# RECAPP Facility Evaluation Report

**St. Mary Of The Lake School**

B4040A  
Slave Lake

**Evaluation Company:** Burgess Bredo Architect  
**Evaluation Date:** June 2 2005  
**Evaluator Name:** Mr. Burgess Bredo

**C3020.08 Carpet Flooring\*\***

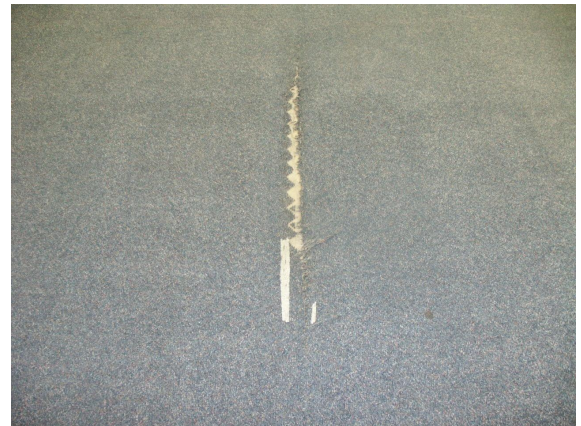
<u>Rating</u>	<u>Installed</u>	<u>Design Life</u>	<u>Updated</u>
3 - Marginal	0	10	JUN-05

**Event: Replace carpet**

Carpet is worn and stained in a number of areas

Replace carpet in selected areas with caropet or sheet vinyl (1,350.0 sq m).
